NSW EPA Site Audit Report Rushes Creek Poultry Production Farm AL005

Prepared for ProTen Pty Ltd

March 2022

Client	ProTen Pty Ltd	
Project	Rushes Creek Poultry Production Farm, Rushes Creek Road, Rushes Creek, NSW 2346 Site Audit Report AL005	
Report Issue	Date	Author
FINAL	09/03/2022	Amanda Lee

Figure 5 Map from SLR (2022) showing the test pitting locations and stockpile staging locations with reference to the capped extent (SLR, 2022: Figure 5)

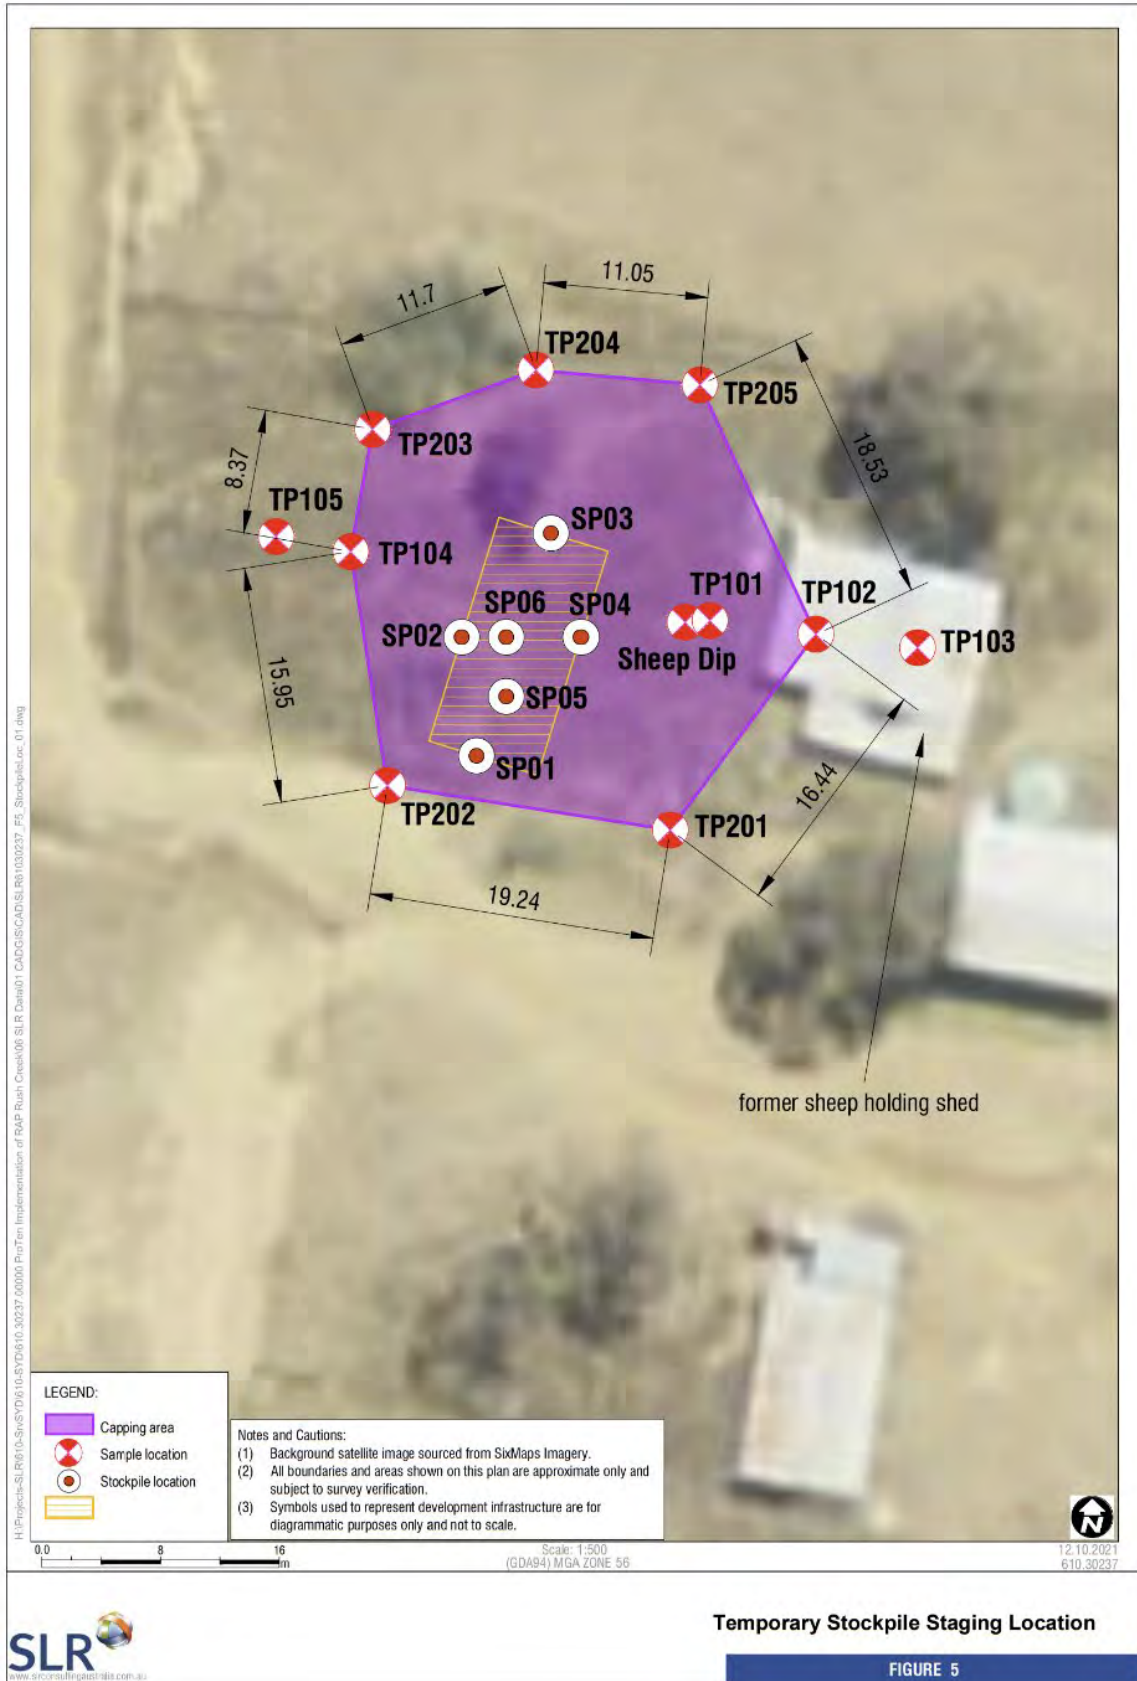
Number	Section	Subject	Auditors comment (20/08/2021)	Response	Auditors comment (16/09/2021)
25	Figures	Figure 1-5	Missing key, scale, northings, and the distance between test pits.	Noted. These items will be included in Validation Report figures	Closed
26	Appendix C	Laboratory Analytical Summary Tables	Table 3 – Where are Table 1 and 2 in Appendix C?	Tables 1 and 2 are included in text (as listed in table of contents)	Closed
27	Appendix C	Laboratory Analytical Summary Tables	In the 2nd round of intrusive works, why are there various rounds reported in the Tables 4-7 when all samples were collected on the same day?	Addition rounds where for delineation of Arsenic. Samples collected all at once and placed on hold during 1st round of analysis.	Closed
